**Seattle
Design
Commission**

**APPROVED
MINUTES OF THE MEETING
2 May 2002**

Projects Reviewed

Animal Control Shelter Addition
Key Tower Base Remodel
Greenwood Library
Ballard Public Library and
Neighborhood Service Center
West Seattle Junction
Dexter Court

Animal Control Shelter Site (↑)

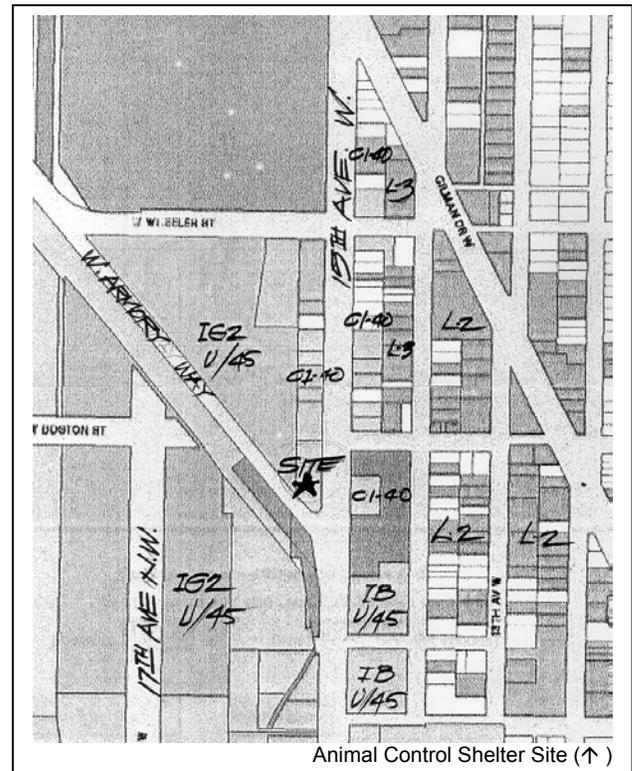
- Wonders if currently, there are wayfinding problems within the facility that might be solved through the expansion.
 - Proponents stated that typically, people do not get lost within the facilities, and the uses throughout the clinic are fairly well-defined. Further stated that the signage for the animal shelter is located on the south end of the building. Through the expansion, the building will open up to 15th Avenue West.

- Recognizes that the meeting room will be a very active space. Believes that the wayfinding should be addressed by the design of the expansion, rather than signage. Believes that different entrances for different uses are confusing.

- Recognizes that the Animal Shelter contains many functions and services here. Believes that a central place or lobby would be appropriate in order to provide directions to and an explanation of all of the uses contained within the facility. Believes that the expansion offers an opportunity to accommodate these needed changes.

- Believes that the entry stair should provide an opportunity to direct people to the correct location. Feels that the entry stair should be generous and obvious as a central location.

- Believes that there should be an organizing element on the lower level of the facility. Agrees that this does not need to be a lobby, but there should be some organizing directional element that provides clarity.

- Recognizes that the building navigation is appropriate for visitors arriving by car. Believes that, after the expansion, not everyone will come by car, and feels that the pedestrian entry from 15th Avenue West should be clear.

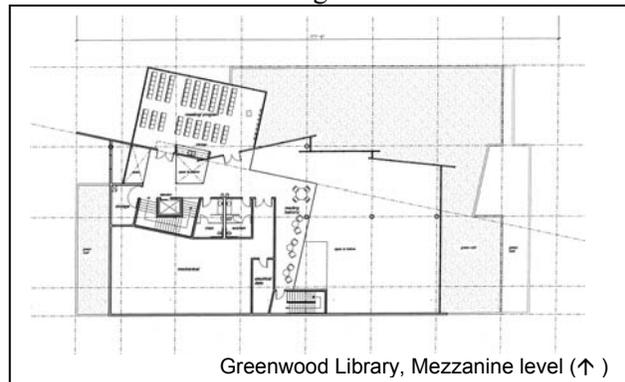
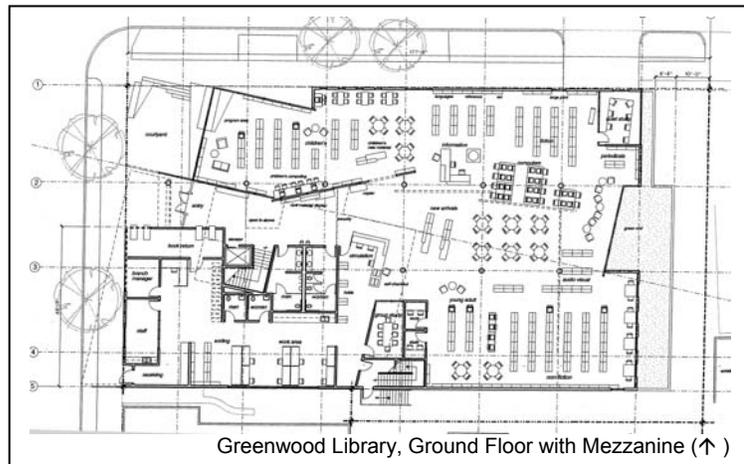
- Would like the design team to explain the differences between the single-story plan and the mezzanine plan.
 - Proponents stated that the building heights of the two schemes are approximately the same, as the mechanical services are on the mezzanine in both schemes. Further stated that the single story scheme is approximately 16,200 square feet, while the mezzanine scheme is approximately 18,000 square feet. Proponents stated that, while the mezzanine scheme would cost approximately \$300,000 more, there are operating costs for library staff to consider as well. The mezzanine level must be monitored by the staff, and the design team has also examined opportunities for electronics or design to provide the required security measures. Two emergency exits from the meeting room are also required. SPL hopes that the meeting room could operate separately in the future.

- Would like the design team to explain the glazing that faces north and continues through the building, sectionally.
 - Proponents stated that these are clerestory windows that would allow north light to highlight the library's central axis. These windows would continue through the building to create a separation between the children's area and different areas.

- Feels that the project is moving in the right direction, from an architectural massing and site design view, but the overall design parti needs further coherence. Feels that the plan diagram is clear. Feels that the sectional relationship between different programmatic uses is clearer. But does not believe that the design has changed significantly since the last Commission review. Believes that the design team is working on the edges of the problems, but is not addressing the architectural problem directly. For example, believes that the theme and fragmentation of the clerestory windows descending into the main space in the mezzanine scheme should be used at the northern edge of the building. Believes that there are still two or three different languages driving the design. Encourages the design team to reduce the conceptual confusion in the design.

- Thought that the mezzanine level plan would resolve more programming concerns or design concerns than it did. Believes that the design of the north and west façades of the library have improved, and relate well to the context.

- Agrees that the schematic design is improving. Is intrigued by the mezzanine scheme, primarily because the main glass box would have a strong presence on the corner. Recognizes that the single-story elevation is very horizontal. Feels that the glass box could be a strong design component of the single-story scheme. Recognizes that formally, the mezzanine scheme incorporates the design components that reinforce the natural theme on the north edge of the building by breaking down the masses and forms.

- Appreciates the scale of the children's section in the mezzanine scheme and the location of the meeting room on the ground floor in the single-story scheme. Recognizes that the angles in the plan respond to the view, but does not believe that these angles are appropriate within the overall design.

- Recognizes that the mezzanine level scheme does not provide many benefits. Actually prefers the massing of the one story scheme.
 - Proponents agreed and stated that the mezzanine scheme includes additional circulation. Most of the public service spaces are on the ground floor, but the mezzanine scheme is difficult, as it separates so many important functional relationships.

- Prefers the scheme with the meeting room located on Greenwood Avenue. Believes that the interior angles could become the design parti of the north wall to strengthen the scheme.
- Believes that the desire for views is overemphasized. Does not believe that people come to the library for the views. Believes that there should be an opportunity to go outside on the green roof.
- Appreciates the design changes that the team has made. Believes that the mezzanine decision will be driven by operating costs and concerns. Does not believe that the design shows that one solution is better than the other.

- Proponents stated that the design team did explore many other mezzanine and single-story schemes with different programmatic relationships. Further stated that there aren't many active spaces within the library's program that could wrap around both facades of the building.

- Proponents stated that the angle of the clerestory windows allow natural light into the central area of the library. Further stated that the columns that bounce in and out of these angles are meant to provide small eddies of activity or other uses. Further stated that SPL staff did study four or five other mezzanine schemes, and the scheme presented to the Commission today represents the scheme preferred by the SPL staff. Further stated that, while the mezzanine scheme is more challenging, SPL is still considering it a possibility.

Perspective view from northwest

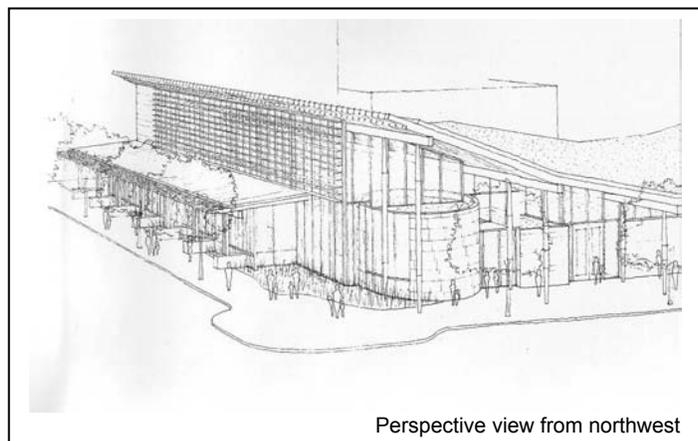
- Would like the proponents to further explain the green roof. Would like to know if this system would be irrigated during the summer.
 - Proponents stated that the green roof would act as normal insulation, and various grasses and sedums could be used. The deck for this green roof system would be similar in form to an egg carton, which functions as a water reservoir system. Proponents stated that the roof would not need to be irrigated during the summer, and the roof would be one of the building components that would express the natural systems and changes in nature over time. The color of the sedum would vary based on the roof slope and the collection of available water. The green roof would be seriously maintained and weeded approximately every six months. Further stated that this would be an exciting roof for adjacent neighbors to look down upon.

- Prefers the meeting room as a solid element. Encourages the design team to play off the relationships between the glazing and the mass of this volume, and the other volumes along the western edge of the building.

- Feels that there should be a skylight at the door of the neighborhood service center, rather than at the elevator.
 - Proponents stated that the skylight is meant to draw people to the elevator and the stairs at the lower level of the parking. Proponents agreed that the location, size, and geometry of the skylights could change.

- Has many concerns about the proposed green roof. Does not believe that the slopes of the roof, at the north and south edges, are amenable to a green roof system. Recognizes that some areas may be hot and dry, and the grasses may not grow as planned. Believes that wind will blow materials from these edges and corners. Feels that the slopes will also affect the sun exposure of the roof, and the exposure will be inconsistent.

- Is not sure that all of the skylights are necessary. Does not understand how these will be incorporated with the green roof, literally and conceptually. Also, believes that some of the skylights at the edges of the roof would be redundant, noting that there are many clerestory windows near the edge of the roof.

- Would like to know if the northwest corner of the building, the meeting room, would be transparent. Believes that the view to the proposed open space to the northwest should be addressed, to improve the connection between the park and the library.
 - Proponents stated that this façade would be translucent, the exposure at this corner should be maximized, and this space should glow at night. Further stated that curtains would be required along these windows, to provide darkness for some meetings.

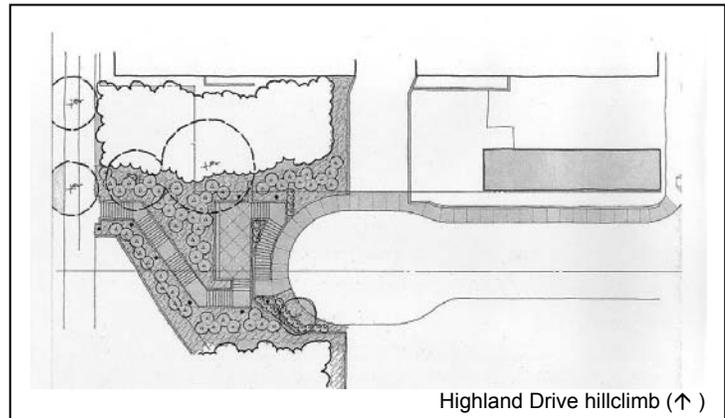
- Recognizes that only a small change has been made to the geometry of the Highland hillclimb. Was hoping for a stronger geometric gesture.
 - Proponents stated that the hillclimb must follow the contours of the grade, so that a shoring wall is not required.

- Understands the logistics driving the design of this hillclimb, but believes that it still needs more design development.
- Recognizes that trees and larger plants would not grow in the small wedge adjacent to the hillclimb landing. Believes that both the landing and the stair should follow the curve of the cul-de-sac.

- Feels that the Dexter Avenue courtyard is now much more inviting. Would like to know the width of the rock wall.
 - Proponents stated that the rock wall would be twelve to fourteen inches.

- Feels that the rock wall should not divide the water features in half. Believes that the rock wall should be an edge or back face of the water features, as the water features are not wide enough for this type of obstruction.
